## Creform (aka Beck North Lot 38) JSP13-61

## PLAN REVIEW CENTER REPORT

Preliminary/Final Site Plan  
Creform (aka Beck North Lot 38)  
JSP 13-61

Re: **FACADE ORDINANCE – Revised Preliminary Façade Review**  
 Creform (FKA Beck North 38, SP06-58), **PSP13- 0131**  
 Façade Region: 3, Zoning District: I-1

A.201

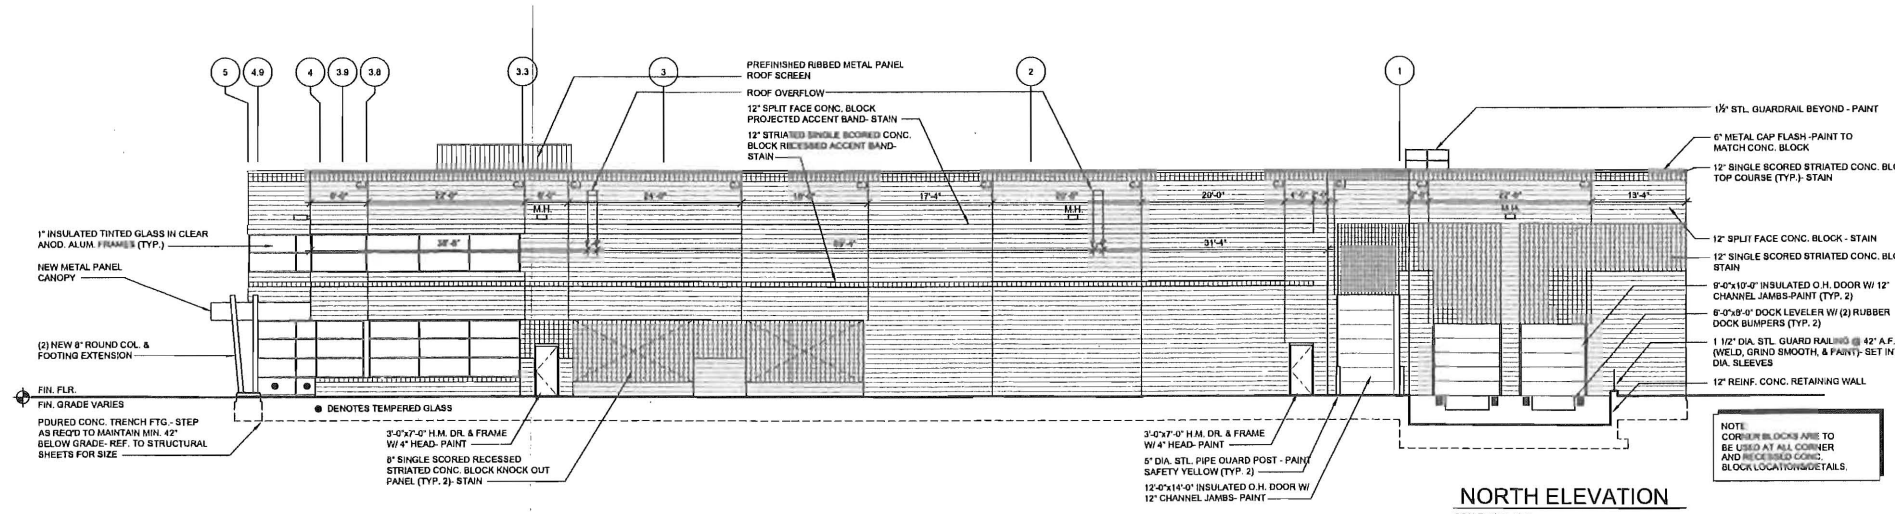
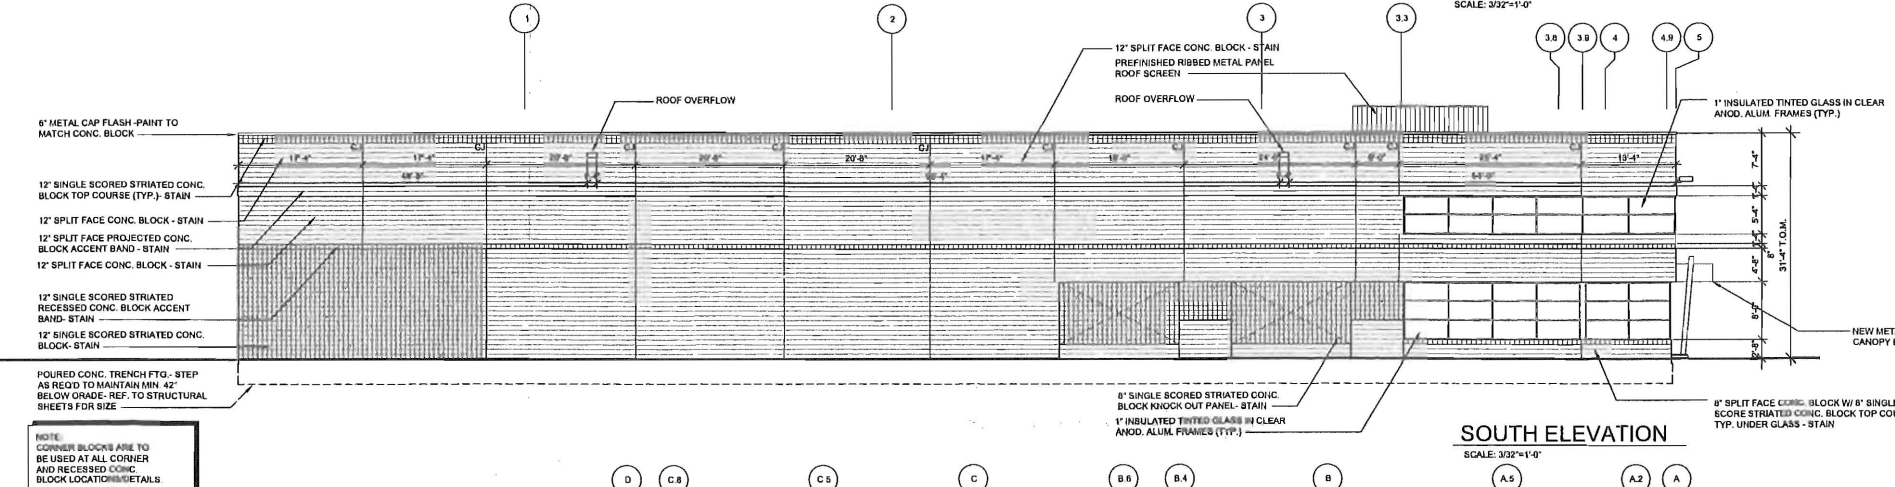
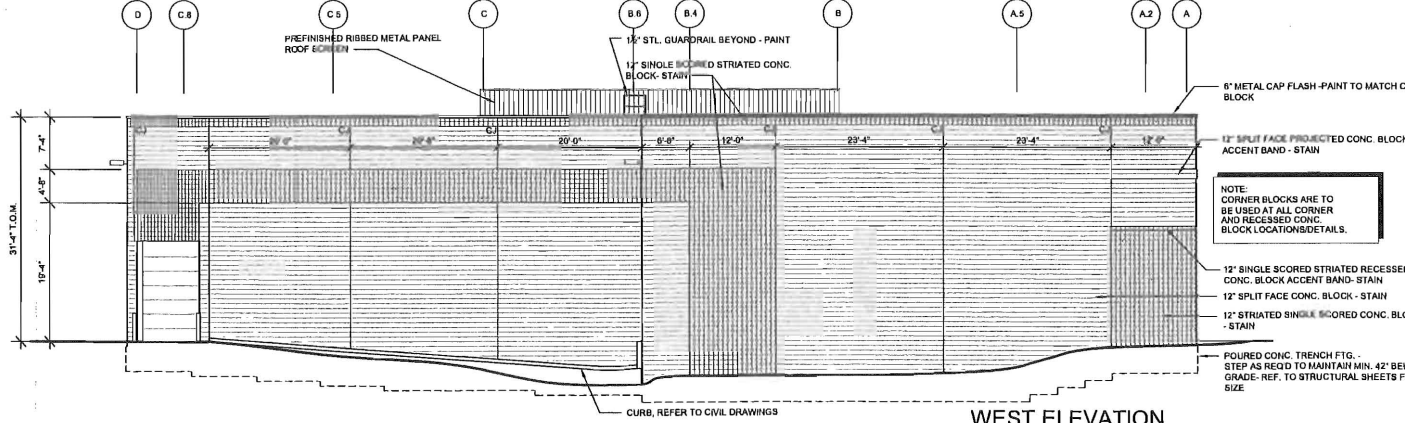
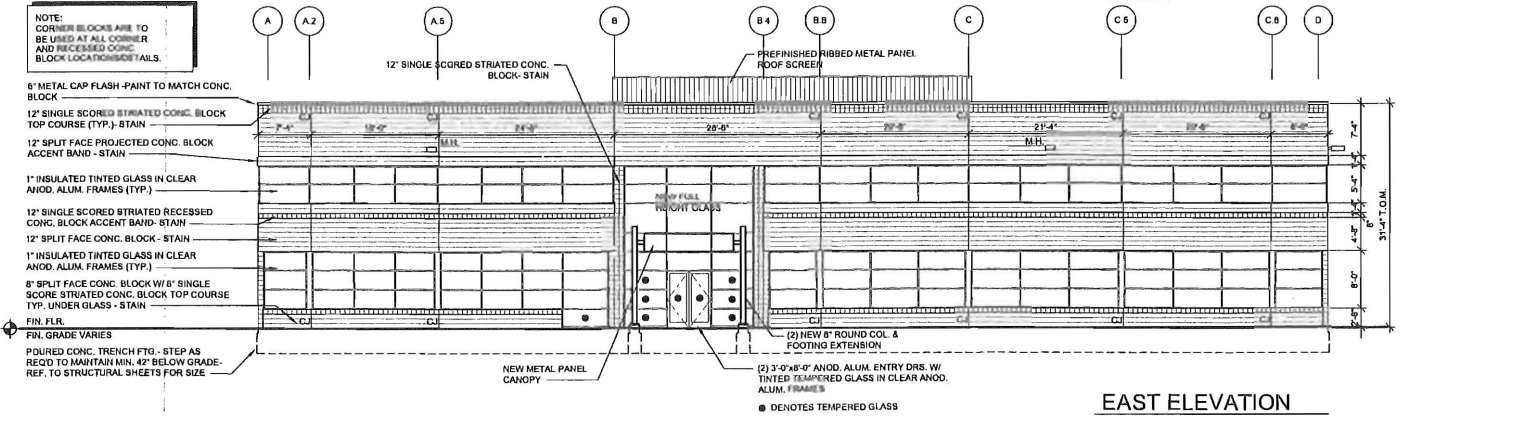
<b>Building</b> (26,000 S.F.)	East (front)	South	North	West	Ordinance Maximum (Minimum)
Split Faced CMU	<b>75%</b>	<b>75%</b>	<b>75%</b>	<b>73%</b>	75% (Note 1)
Striated Scored CMU	<b>17%</b>	<b>23%</b>	<b>23%</b>	<b>23%</b>	50% (Note 1)
Flat Metal Panels	1%	1%	1%	0%	75%
Ribbed Metal Panel	7%	1%	1%	4%	50%
Note 1 - The combined percentage of all types of CMU shall not exceed 75% (Footnote 13 of the Façade Chart).

As shown above all facades are in violation of footnote 13 of the Façade Ordinance which states that the combined percentage of all types of CMU shall not exceed 75%. This project was originally approved by the Planning Commission on February 14, 2007 and was in full compliance at that time. Footnote 13 was added to the Façade Ordinance after that date. Although the revision results in slight variations in the percentages of materials as compared to the original design, the overall design is consistent with what was approved in 2007.

**Recommendation** - It is our recommendation that the design is consistent with the intent and purpose of the Façade Ordinance and that a Section 9 Waiver be granted for the overage of the combined types of CMU.

We are in receipt of the review letters regarding the proposed façade changes at Creform. We would like to request a façade waiver as indicated in the façade consultant's review letter and will comply with any other comments noted in the review letter on the next plan submittal.
